Proposed Technical Specification
Modification

Item No.	Technical Specification	Description of Change	Reason for Change
1.	Index Page III	New Shutdown Margin Pages	Revised Shutdown Margin Designations

Figure 3.1-1

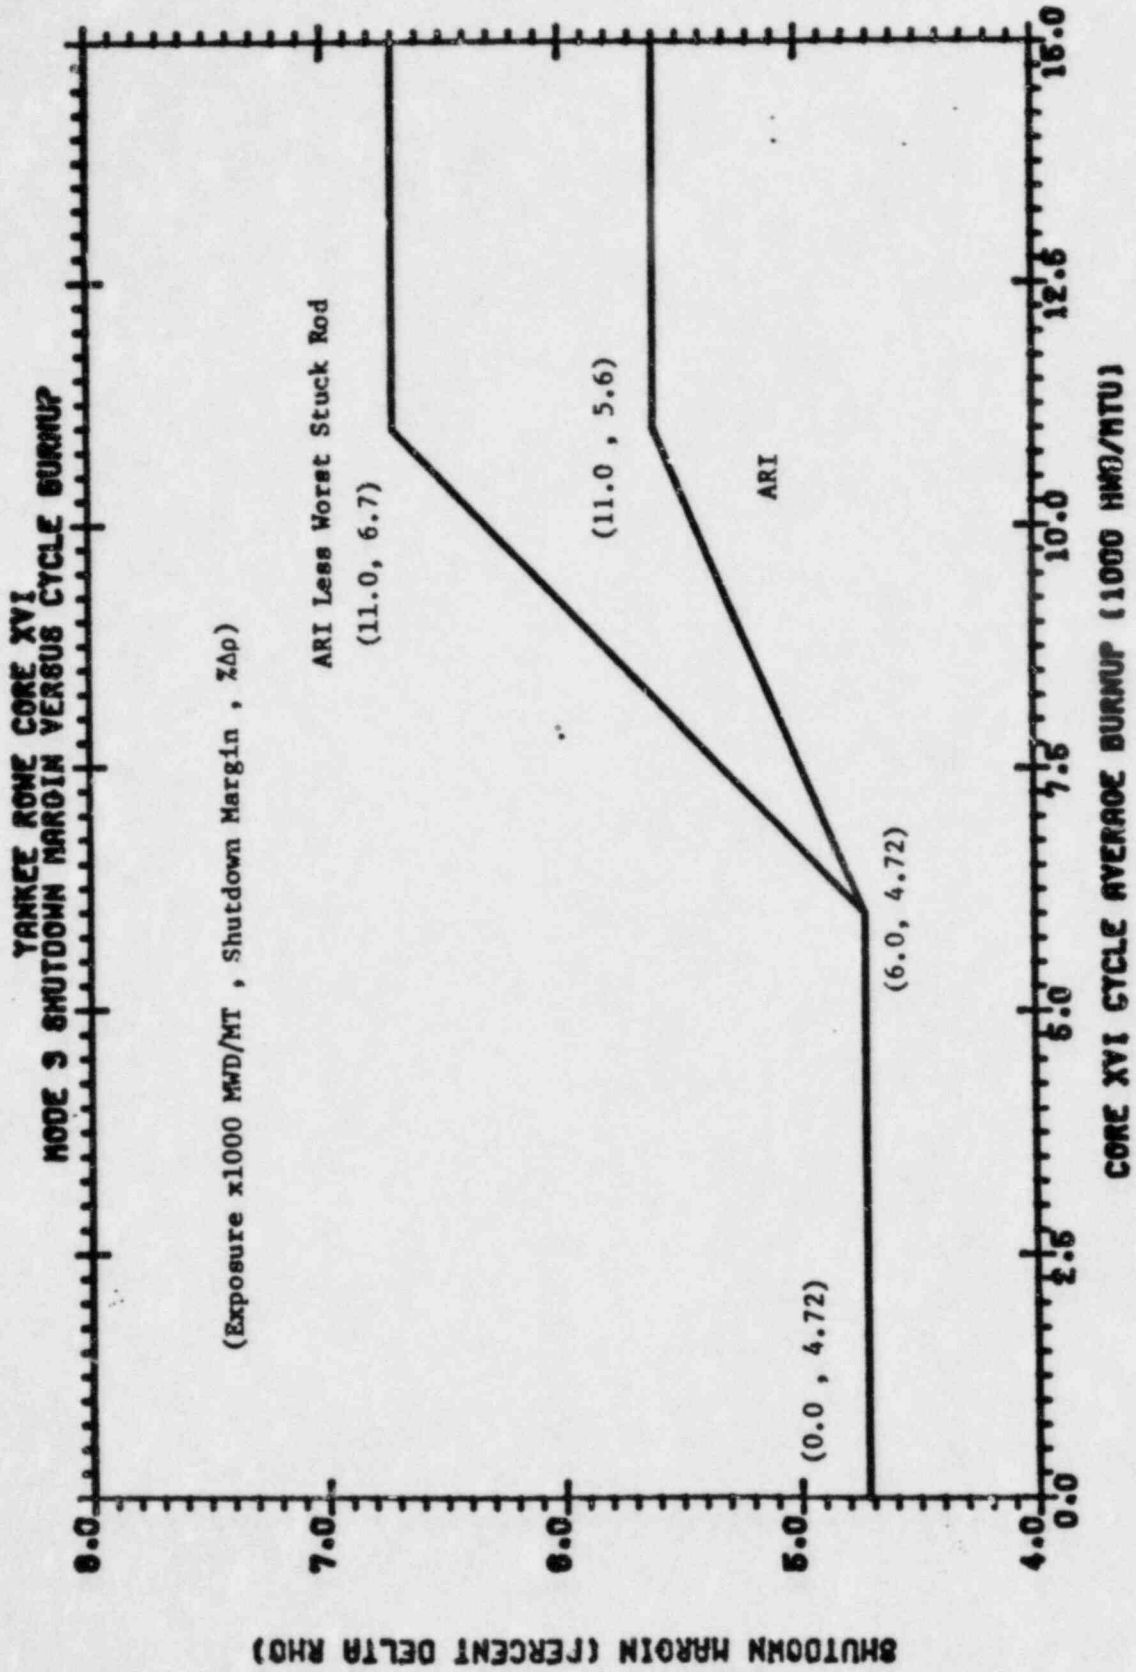
7.	Figure 3.1-1 Page 3/4 1-2B	Figure required for the new Specification 3.1.1.1.2	Refer to Section 7.10 of YAEC-1325
8.	3.1.3.1.a Page 1-23	Change Specification Number 3.1.1.1 to 3.1.1.1.1	New numbering implemented

3.1.1.1.2 The shutdown margin shall be determined from Figure 3.1-1 for main coolant average temperatures above 490°F. Shutdown margin for $T_{avg} \leq 450$ is 4.72% $\Delta k/k$. The shutdown margin requirement is a linear function between 450°F and 490°F.

FIGURE 3.1-2

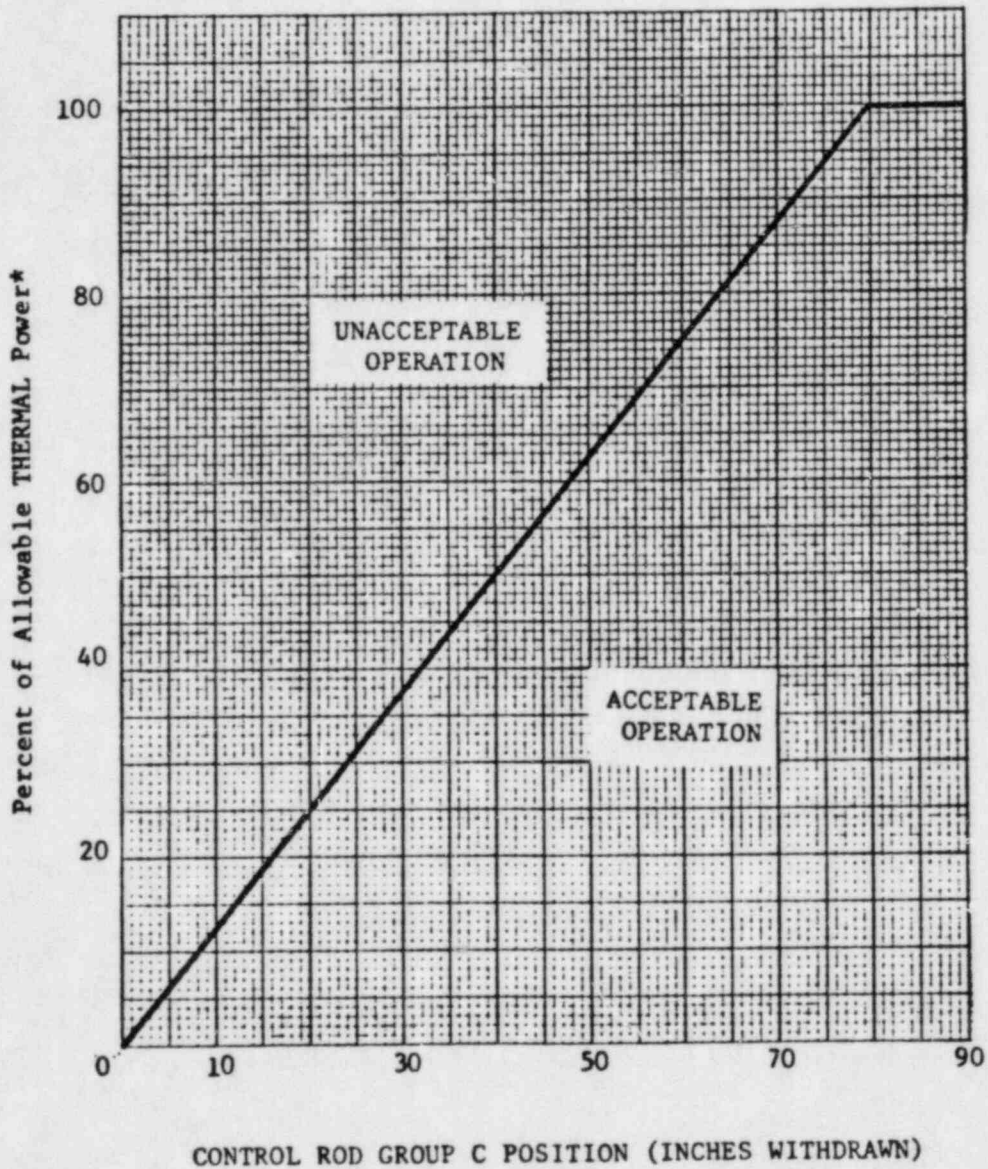
11.	3.1.3.5 Page 3/4 1-28	Modify to reflect new Figure Numbering, 3.1-1 to 3.1-2	Accomodate new Figure 3.1-1
12.	Figure 3.1-2 page 3/4 1-29	Replace Core XV Figure 3.1-1 with the attached Figure 3.1-2	More restrictive curve for Core XVI

3.1.3.5 The control groups shall be limited in physical insertion as shown in Figure 3.1-2.

Figure 3.2-1

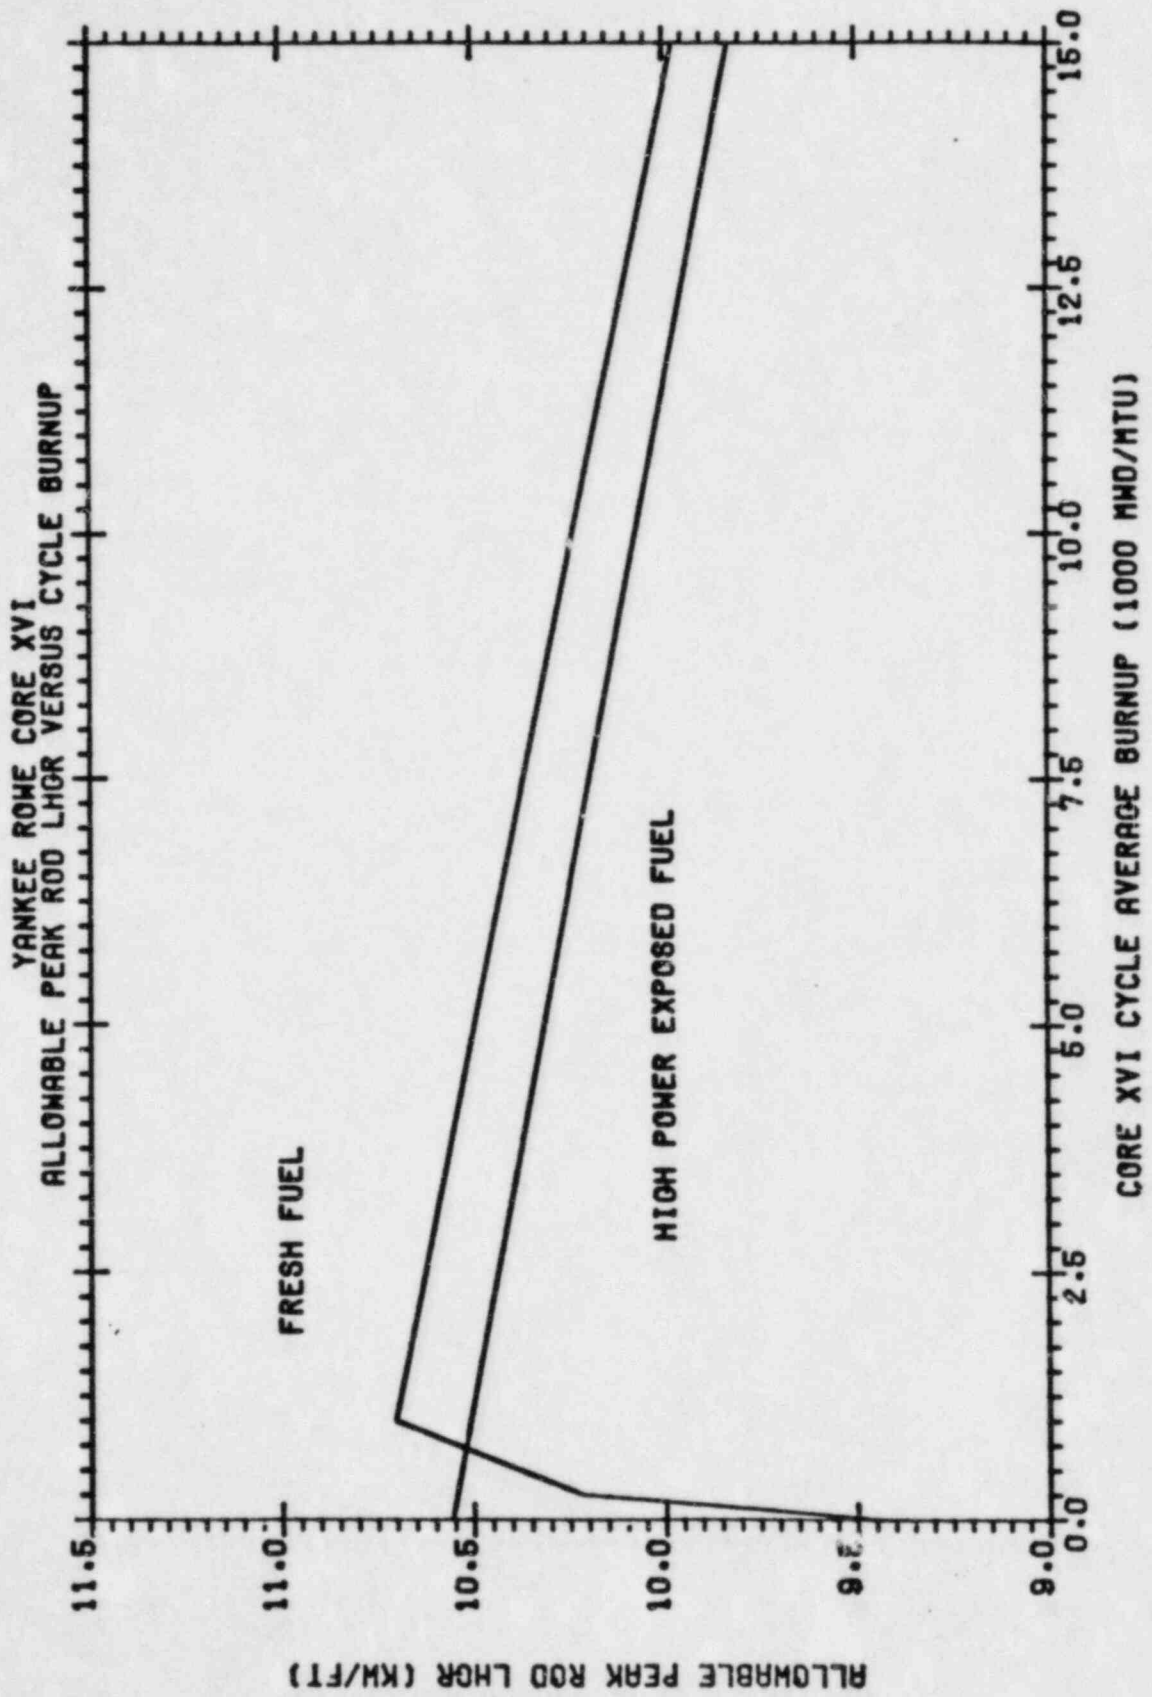
15.	4.2.1.3 page 3/4 2-3	Removed	Not required to be within the bounds of the safety analysis
16.	Figure 3.2-1 page 3/4 2-4	Replaces Core XV Figure 3.2-1 with the attached revised Figure 3.2-1	Reflects the Core XVI ECCS evaluation. Refer to Section 9.0 of YAEC-1325

Figure 3.2-3
Multiplier for Xenon Redistribution as a
Function of Exposure

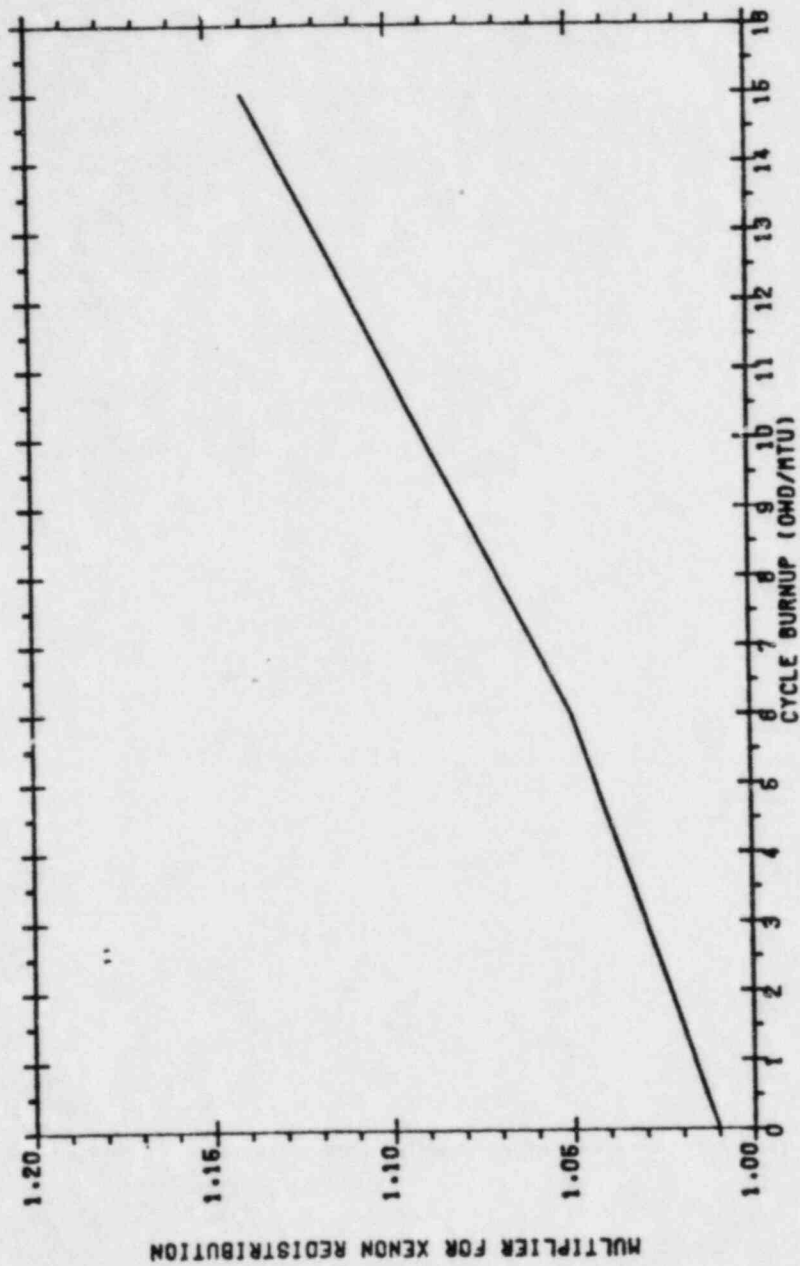
17.	Figure 3.2-2 page 3/4 2-5	Replaces Core XV Figure 3.2-2	Core XVI Specific
18.	Figure 3.2-3 Page 3/4 2-6	Replaces Core XV Figure 3.2-3	Core XVI Specific

Figure 3.2-4
Multiplier for Reduced Power as a Function of Exposure

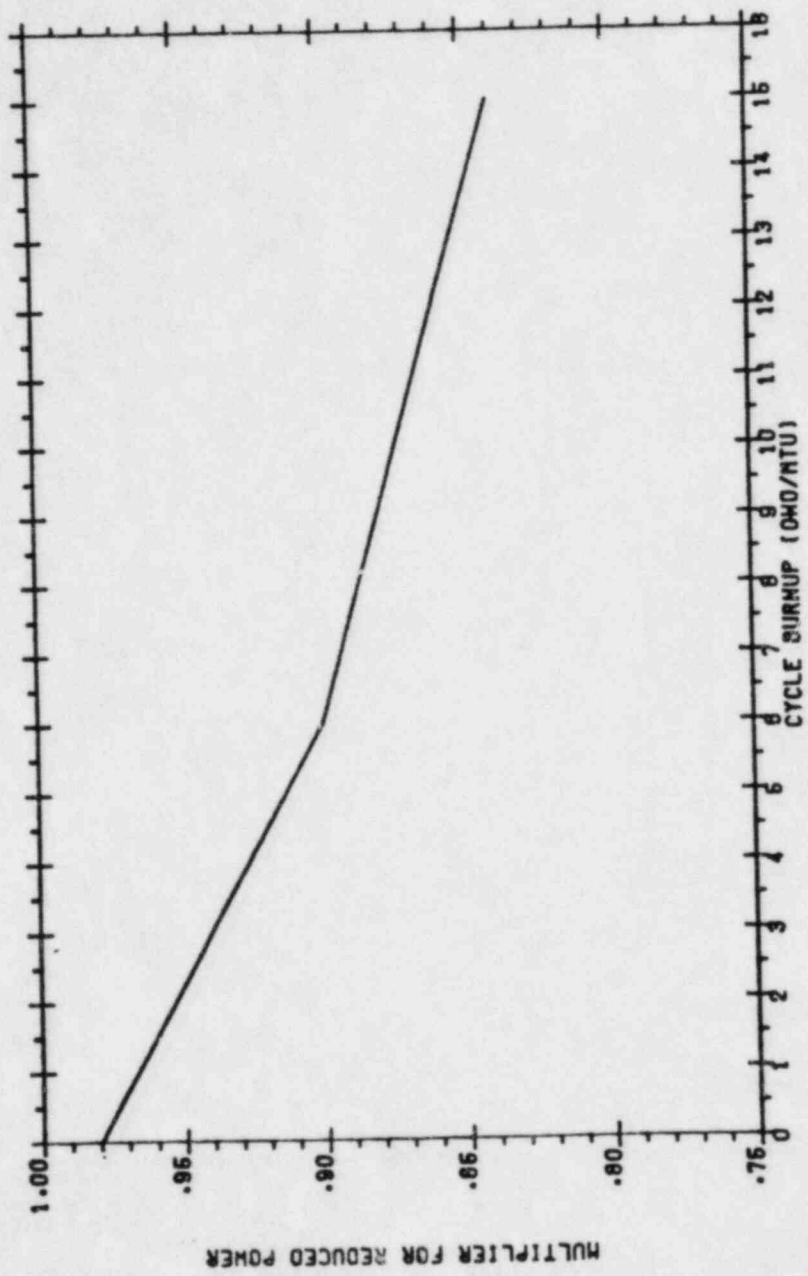
19.	Figure 3.2-4 page 3/4 2-7	Replaces Core XV Figure 3.2-4	Core XVI Specific
20.	4.2.2.1.3.a&b page 3/4 2-9	Remove part b to continue Measurement Uncertainty Changes	Only valid for Core XV
